91-2, *Publication Date: JANUARY 23, 1991*

| <ul style="list-style-type: none">• Chassis - Low Clearance Concerns - Low Profile Or Low Rider Models With 6.6L And 7.8L Ford Diesel Engines• Oil - Filter - 6.6L And 7.8L Ford Diesel - New Shorter Filter Available for "Low Profile Or Low Rider" Models | Article No. 91-2-14 |

MEDIUM/HEAVY TRUCK:

1987-91 CARGO SERIES, F & B SERIES, L SERIES

Figure 1 - Article 91-15-13

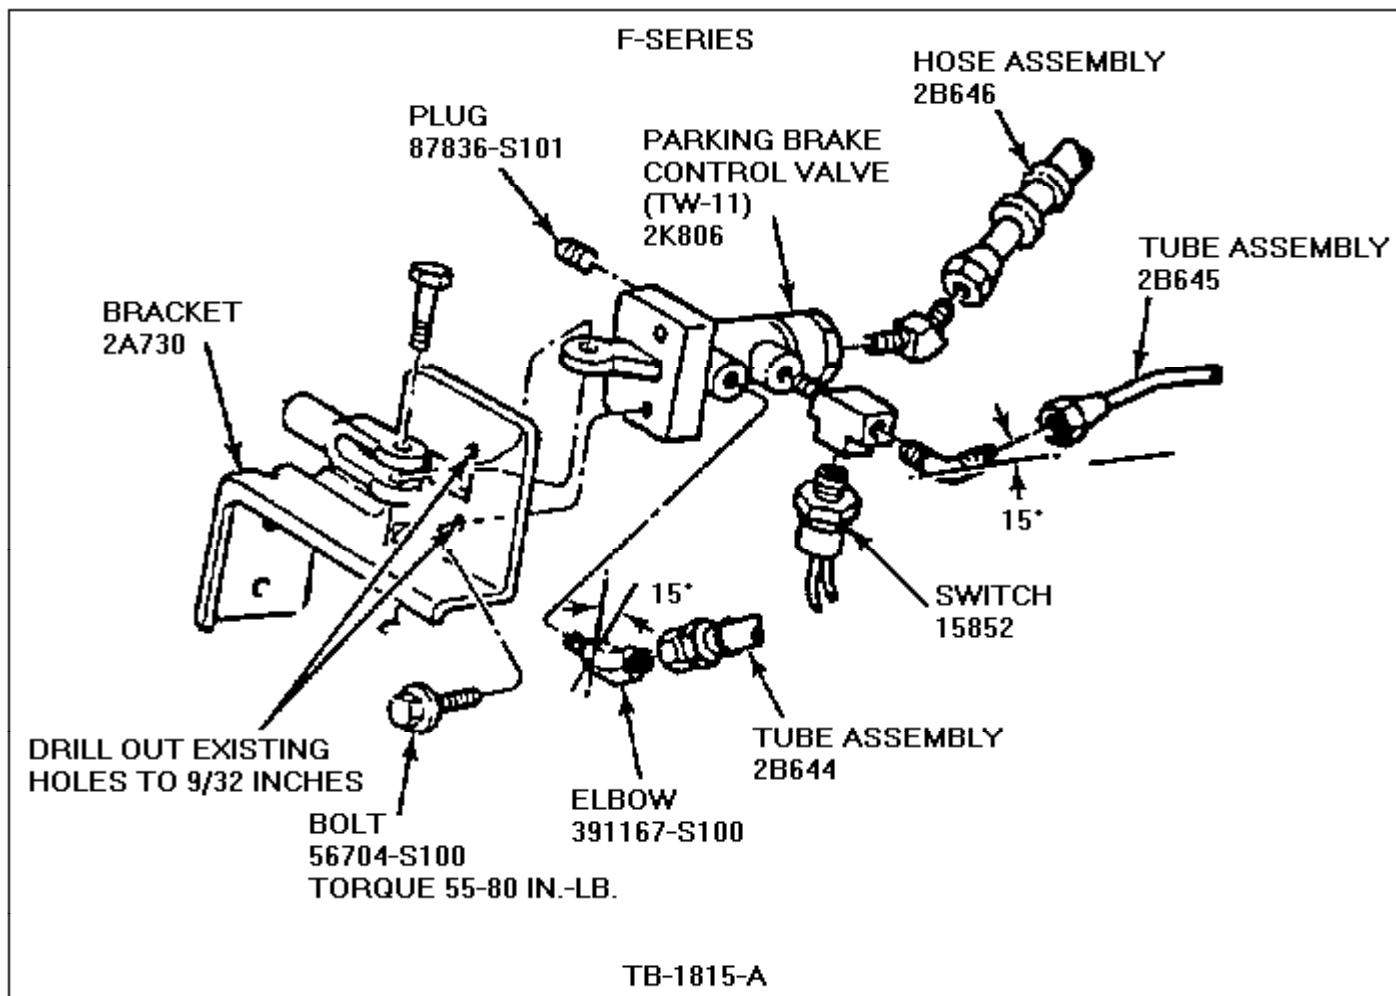
Revised TW-11 parking brake valves are available for service. The new valves have a new Viton "o"-ring at the input fitting to improve sealing. The valve used on F, L, and LN Series trucks also has a new material and casting pattern to reduce the number of ports. With fewer ports the number of possible leak points is reduced.

If service is required, install a new TW-11 parking brake valve. See the following chart for the correct part usage. Refer to the Medium/Heavy Truck Shop Manual, Page 12-75-8 for installation procedures for the F-Cowl and B Series Trucks. Use the pictorial installation procedure shown in Figures 1 and 2 for the F, L and LN Series Trucks.

Figure 1 - Article 91-16-15

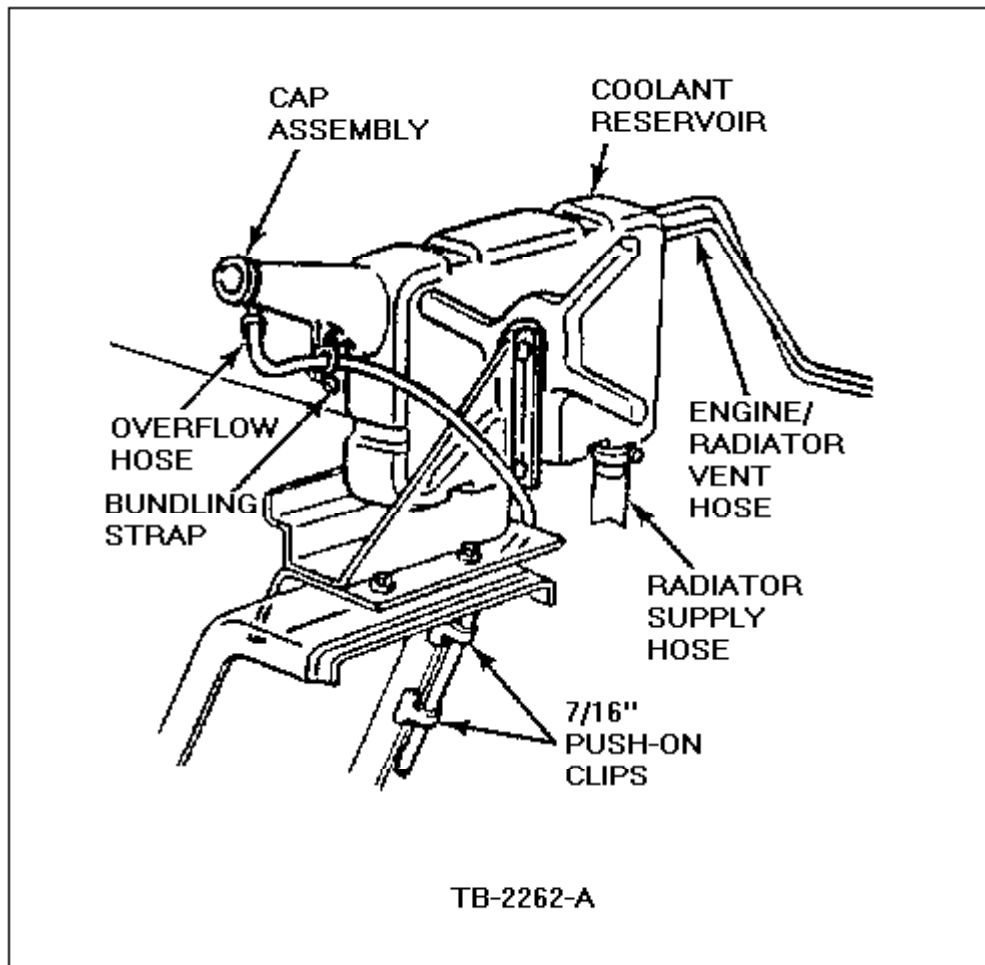
Install a new more durable cooling system reservoir (F1HZ-8A080-D). Some additional components are required to complete a retrofit. Refer to the Parts Block and Figure 1 for correct parts usage. Refer to the 1986-91 Cargo Truck Shop Manual, Section 27-02, for complete cooling system service details.

Figure 1 - Article 91-16-16

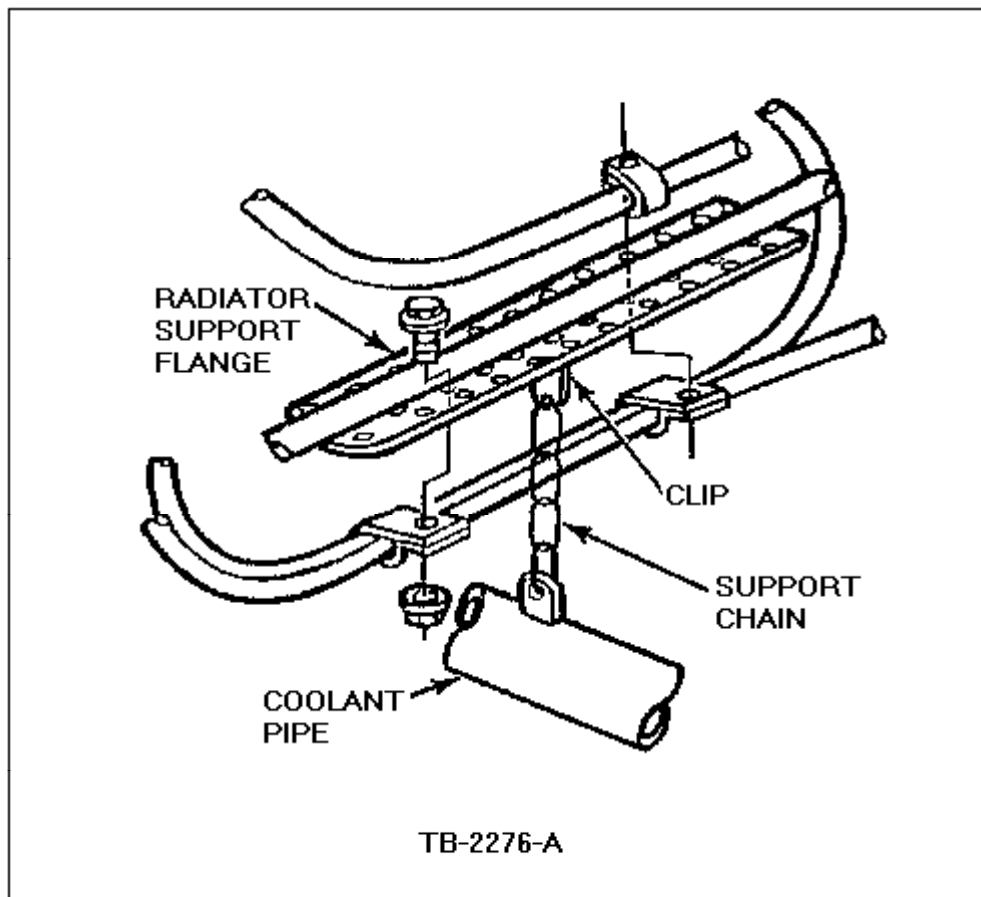
1. Remove one link from the chain, Figure 1. Reattach as described in Step 2.

2. Reposition the support chain in the sixth hole from the front of the flange on the radiator support rod, Figure 1.

Figure 1 - Article 91-18-17

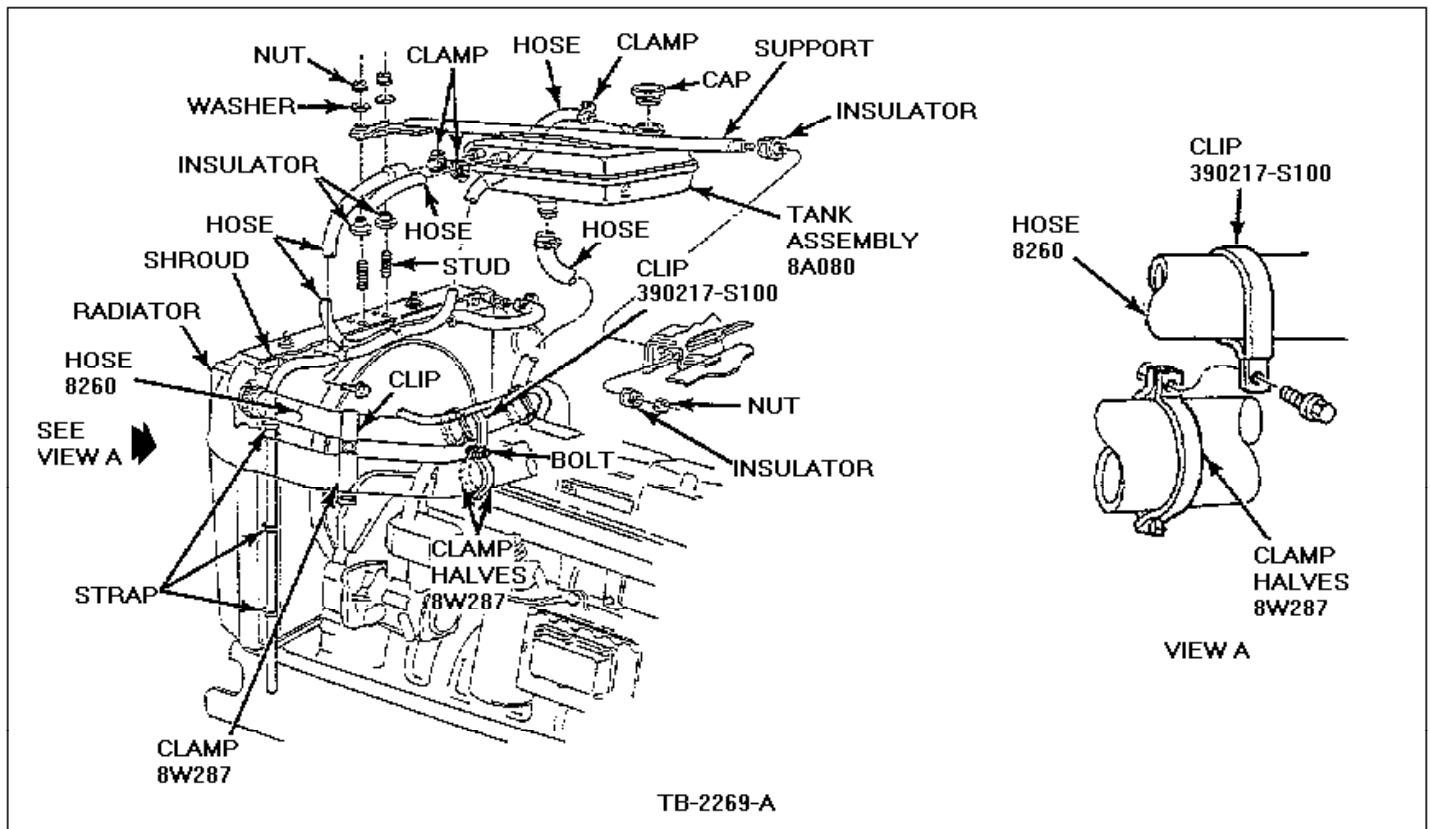
Install a second support (half clamps with clip) and position it as shown in Figure 1.

Figure 1 - Article 91-19-13

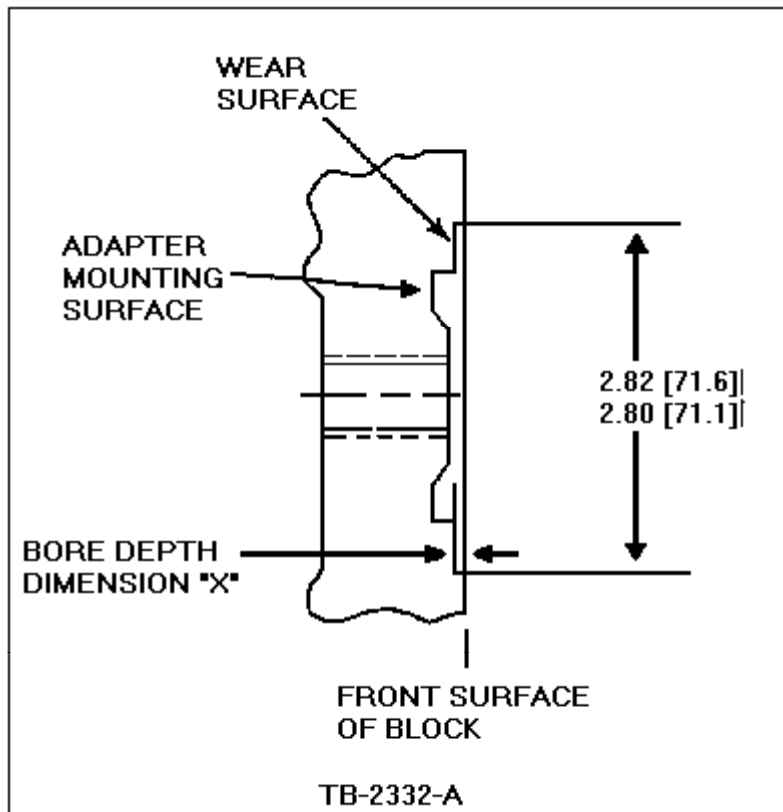
1. If camshaft drive gear end play is greater than 0.432 mm, (0.017 inches), rework is recommended.
2. Measure bore depth of dimension "X" at the 3,6,9 and 12 o'clock positions. Refer to Figure 1.

- a. If any two measurements differ more than 0.152 mm (0.006 inches), rework is recommended.
- b. If the "X" dimension is greater than 0.79 mm (.031 inches) at any point around the diameter, rework is recommended.

1. Rebore the block dimension "X" to new depth of 2.34 mm (.092 inches). Refer to Figure 1.

Figure 2 - Article 91-19-13

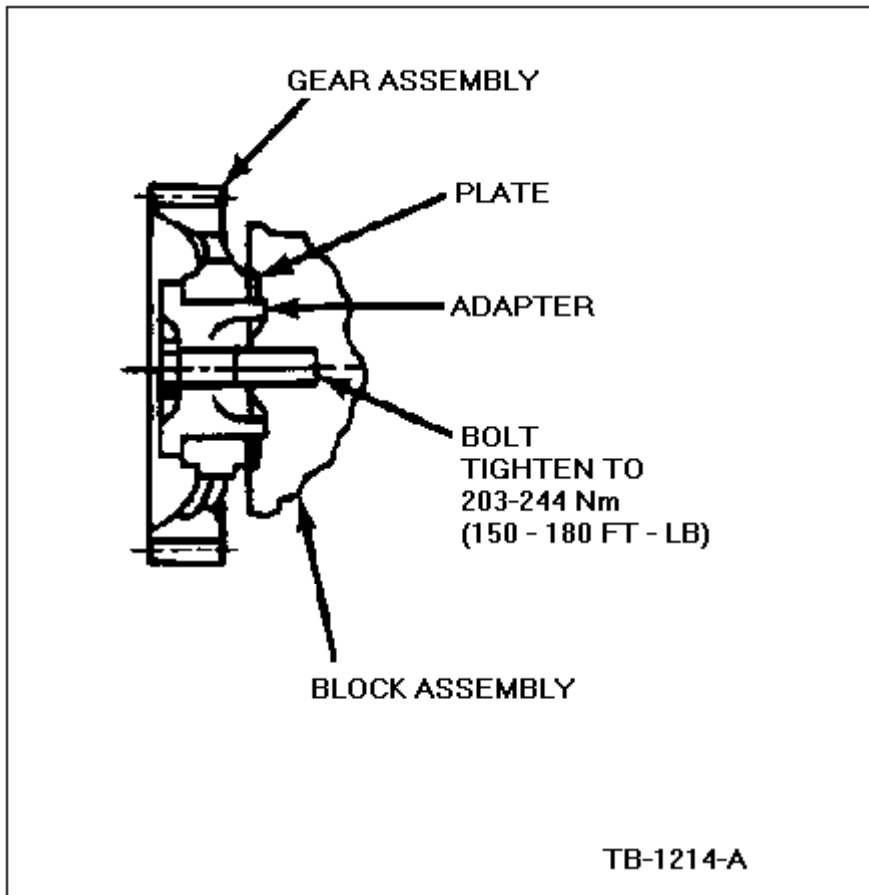
1. Assemble new adapter into gear. Refer to Figure 2.

2. Assemble wear plate onto nose of adapter, with the chamfered edge of the wear plate toward the engine block.
3. Install the adapter as follows:
 - a. Insert the bolt through the adapter. Refer to Figure 2.
 - b. Assemble gear, adapter and wear plate to engine block. Refer to Figure 2.
 - c. Tighten the bolt to 150-180 lb.ft. (203-244 N-m). Refer to Figure 2.
4. Check the cam drive gear end play. The end play should be 0.05-0.38 mm (0.002-0.015 inches).

Figure 1 - Article 91-20-20

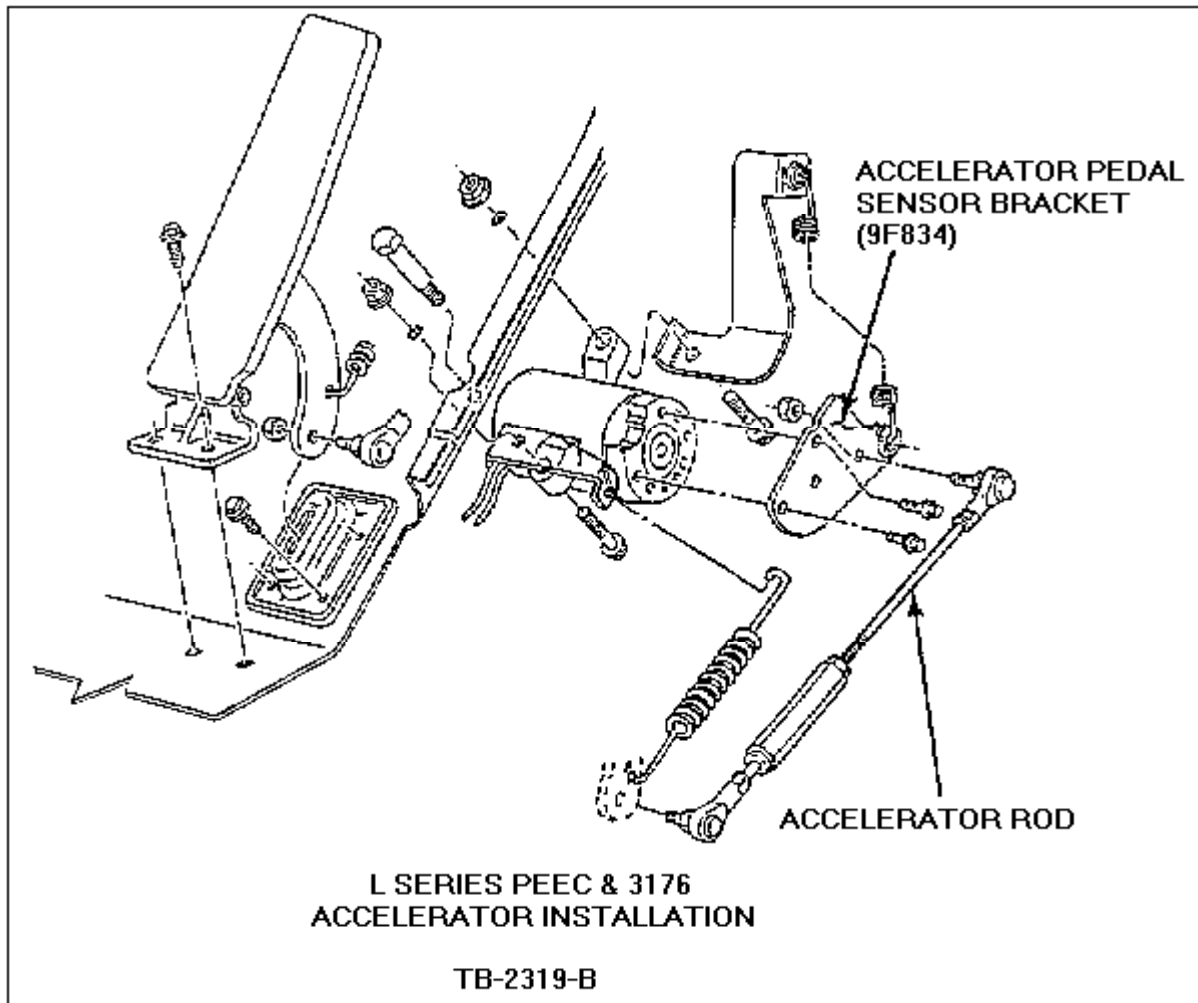
Replace the existing sensor bracket with a new sensor bracket (F1HZ-9F834-A) to lower the forces in the rod to prevent it from extending prior to sensor rotation, Figure 1. Refer to the 1991 L-Series Truck Service Manual, Section 25-60, for details.

Figure 1 - Article 91-20-21

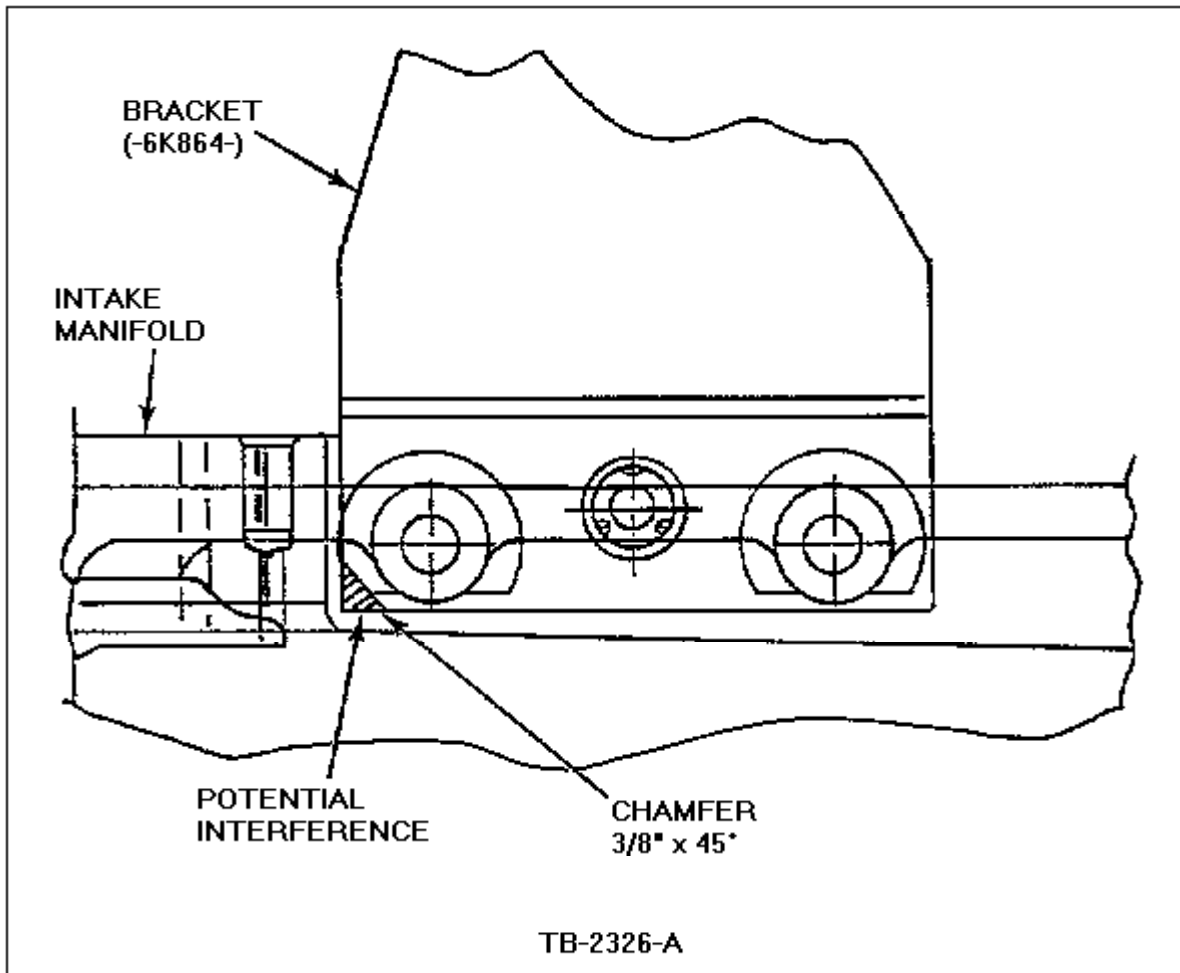
1. Check the adaptor bracket clearance to the engine intake manifold to see if there is a minimum clearance of 1/16" (1.588mm).
2. If this minimum clearance is not evident and the bracket is reusable, rework it as shown in Figure 1.

- a. Remove the bracket and grind the rear, lower corner providing a chamfer of 3/8" (9.525mm) x 45°.
- b. Reinstall the bracket using the existing fasteners. Tighten all fasteners to 16-24 lb-ft (27-33 N-m).
3. If the adaptor bracket is not reworkable, install a new bracket (F1HZ-6K864-C) which is already chamfered.

Figure 1 - Article 91-21-13

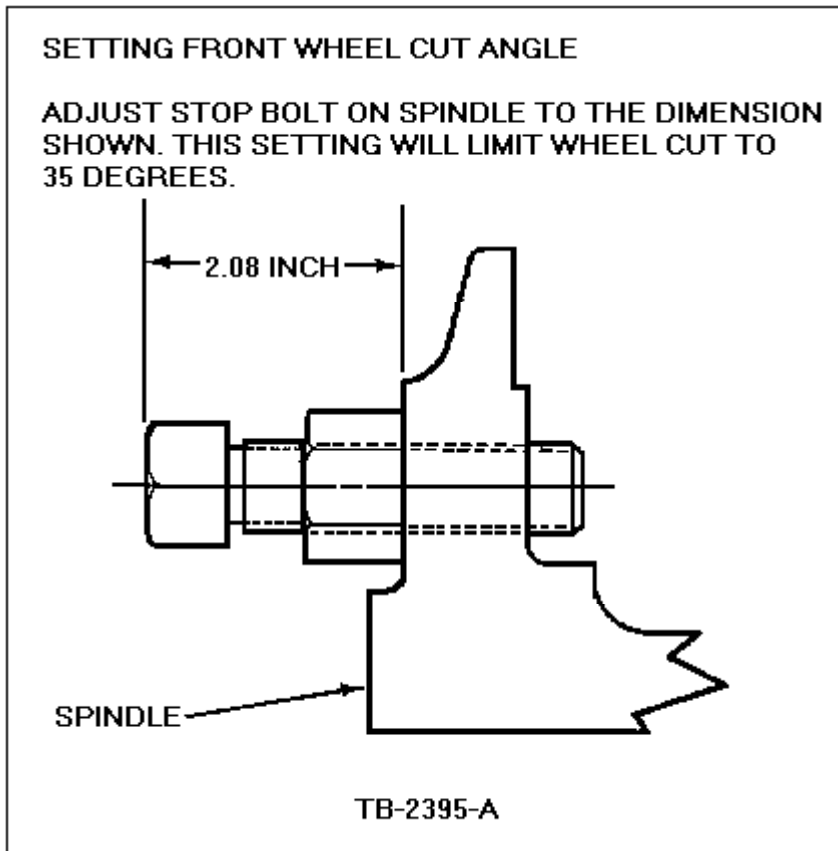
1. Replace the right hand Ackerman arm with (E7HZ-3130-K) and the left hand Ackerman arm with (E7HZ-3131-K). Reuse the original nuts and keys.
2. Torque the tie rod nuts to 110-150 lbs.-ft.(149-203N-m) and torque the Ackerman arm nuts to 540-730 lbs-ft.(732-990N-m).
3. Reduce the wheel "cut angle" from 40° to 35°. Refer to figure 1.

4. Reuse the original tie rod and adjust the toe-in after installation of the new Ackerman arms to the original $1/8" \pm 1/16"$ setting on Merrill dynamic alignment equipment.
5. Torque the tie rod clamp bolts to 50-70 lbs.- ft.(67-95N-m).

Figure 1 - Article 91-21-14

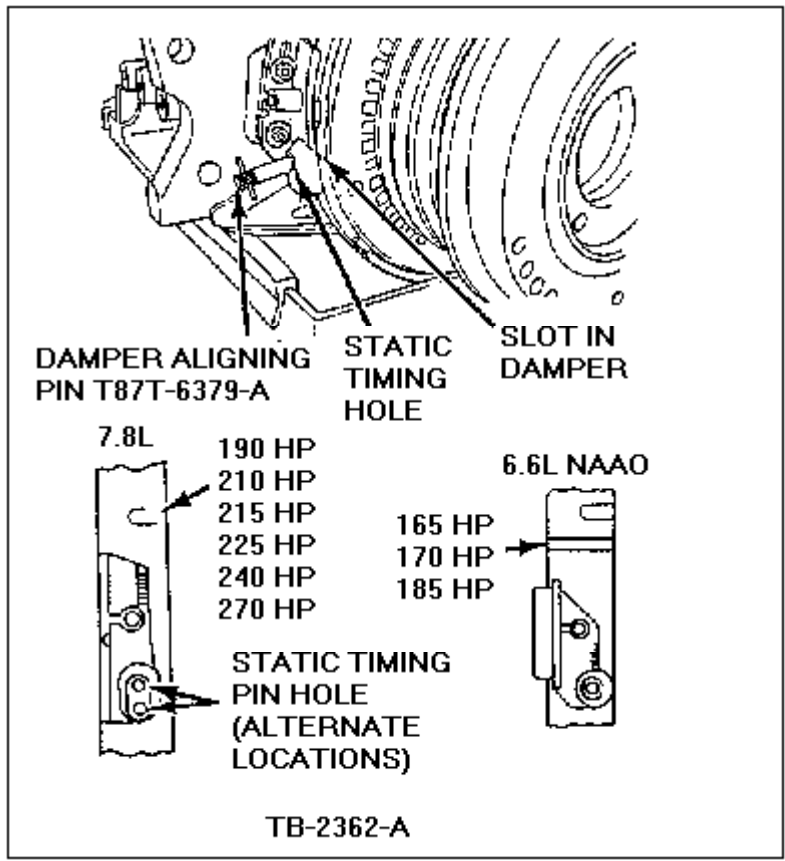
1. Remove the injection pump access cover and basket.
2. Rotate the engine clockwise.
 - a. Set engine at correct static timing angle with number 1 piston on the compression stroke.
 - b. Fit Damper Aligning Pin (T87T-6379-A) through the timing bracket into the correct crankshaft damper groove, Figure 1.

Figure 2 - Article 91-21-14

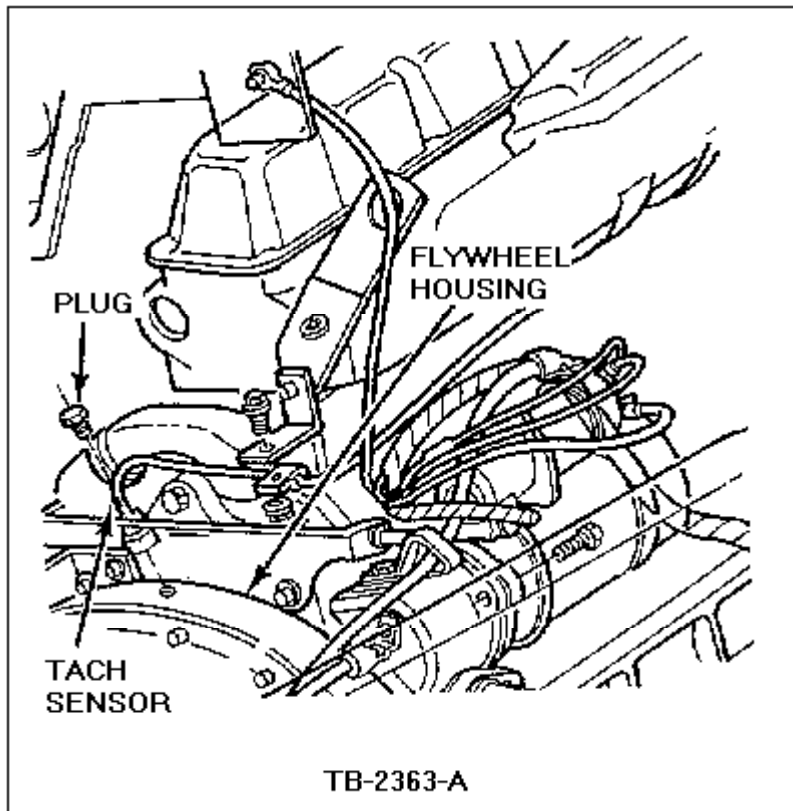
NOTE:
 WHEN UNABLE TO ACCESS THE FRONT DAMPER MOUNTING BOLT TO ROTATE THE ENGINE, REMOVE THE PLUG OR TACH SENSOR AT TOP OF FLYWHEEL HOUSING TO ROTATE FLYWHEEL RING GEAR WITH LARGE SCREWDRIVER, FIGURE 2.
